CONTROLLED DOCUMENT TRANSMITTAL

TRANSMITTAL #: EP-21-0007

Procedure Title: Meteorological Information and Dose Assessment System (MIDAS)

Procedure No: IP-EP-340 Existing Rev: 7 New Rev: 8 DRN/EC No: 21-00118

FLOWCHART FOR GENERAL EMERGENCY PROTECTIVE ACTION RECOMMENDATIONS

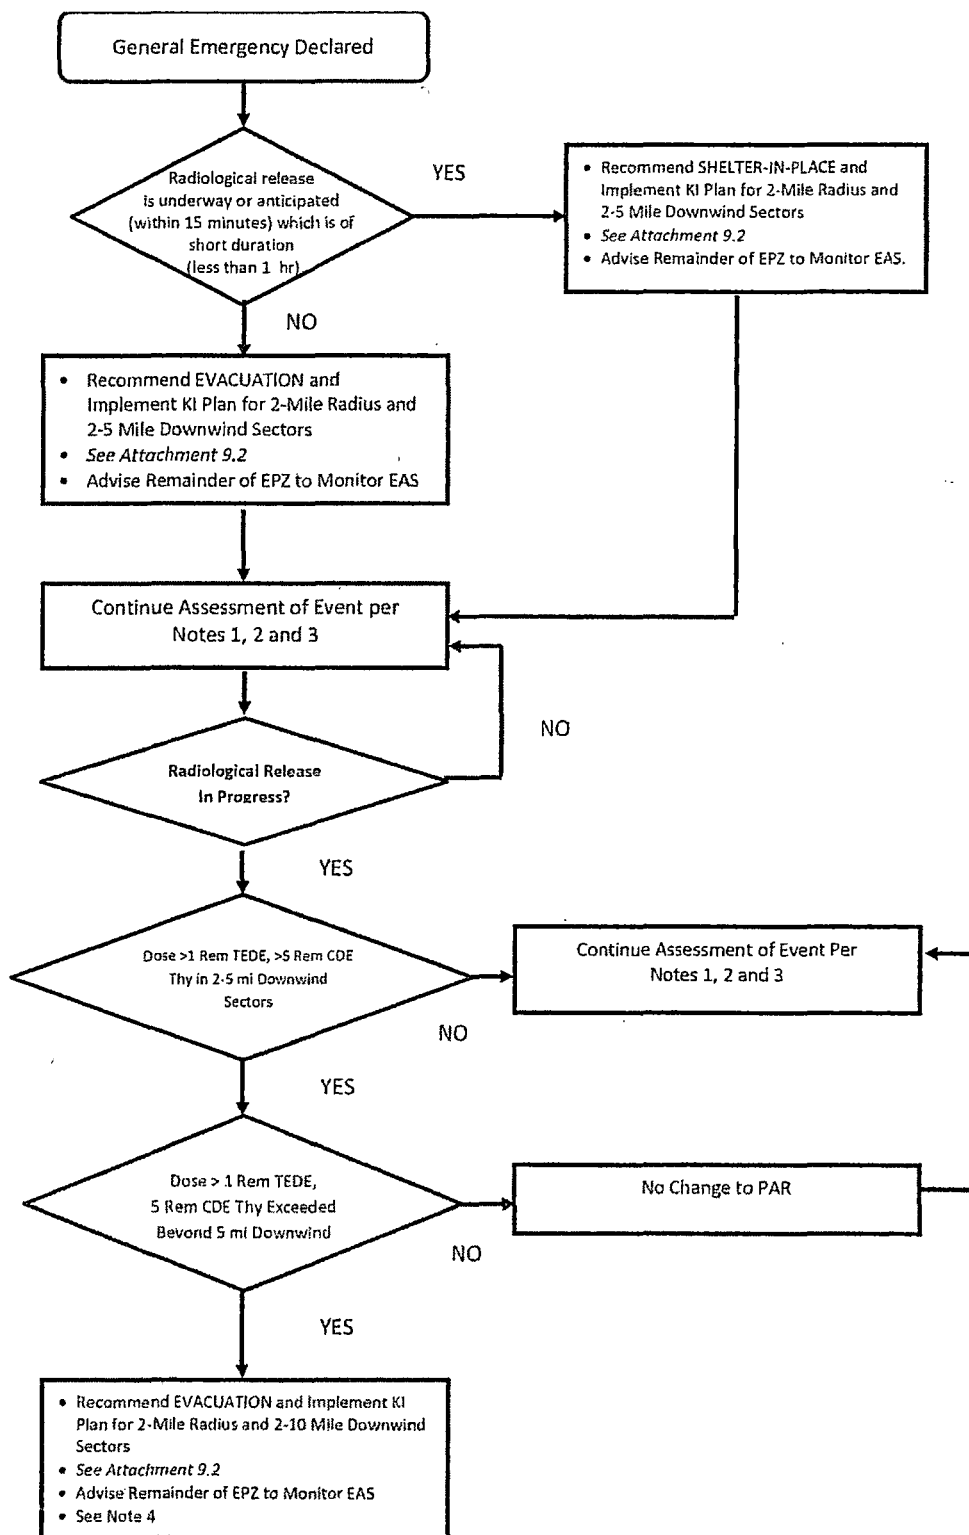
3.	<p>FLOWCHART FOR GENERAL EMERGENCY PROTECTIVE ACTION RECOMMENDATIONS</p> <p>Attachment 9.1 Sheet 2 of 2</p>	<p>NOTE 1: Rapidly Progressing Severe Accident IF:</p> <ul style="list-style-type: none"> • First PAR after GE declared AND, • Containment Loss Conditions (Table F-1) AND EITHER: • Containment Rad Monitors R-25 or R-26 > 68 R/hr OR, • Conditions for EALs AG1.1, AG1.2 or AG1.3 have been met. • If these criteria cannot be immediately confirmed, assume a RPSA is NOT occurring. 	Previous NOTE 1 removed.	No	<p>No - See Change #2 above. RPSA conditions no longer apply after defueling.</p> <p>The meaning or intent of description in the emergency plan, facilities or equipment described in the approved Post-Shutdown Emergency Plan (PSEP) or a process described in the PSEP are not affected by this change. No further evaluation is required for this change.</p>

4.	FLOWCHART FOR GENERAL EMERGENCY PROTECTIVE ACTION RECOMMENDATIONS Attachment 9.1 Sheet 2 of 2	Previous Notes 2,3,4 and 5	Previous Notes 2, 3, 4 and 5 now renumbered as Notes 1,2,3 and 4	Yes	No – The previous notes 2-5 were renumbered as Notes 1-4 due to the removal or previous Note 1 (describing the RPSA). No other wording changes were made in the remaining notes. The meaning or intent of description in the emergency plan, facilities or equipment described in the approved Post-Shutdown Emergency Plan (PSEP) or a process described in the PSEP are not affected by this change. No further evaluation is required for this change.

5.	FLOWCHART FOR GENERAL EMERGENCY PROTECTIVE ACTION RECOMMENDATIONS Attachment 9.1 Sheet 1 of 2	Two blocks in flow chart state: "Continue assessment of event as per Attachment 9.1 Notes 2, 3 and 4" Bottom block states: "See Note 5"	Wording in same blocks now state: "Continue assessment of event per Notes 1, 2 and 3" Bottom block states: "See Note 4"	Yes	No – This is an editorial change made to conform to the revised notes numbering. The meaning or intent of description in the emergency plan, facilities or equipment described in the approved Post-Shutdown Emergency Plan (PSEP) or a process described in the PSEP are not affected by this change. No further evaluation is required for this change.
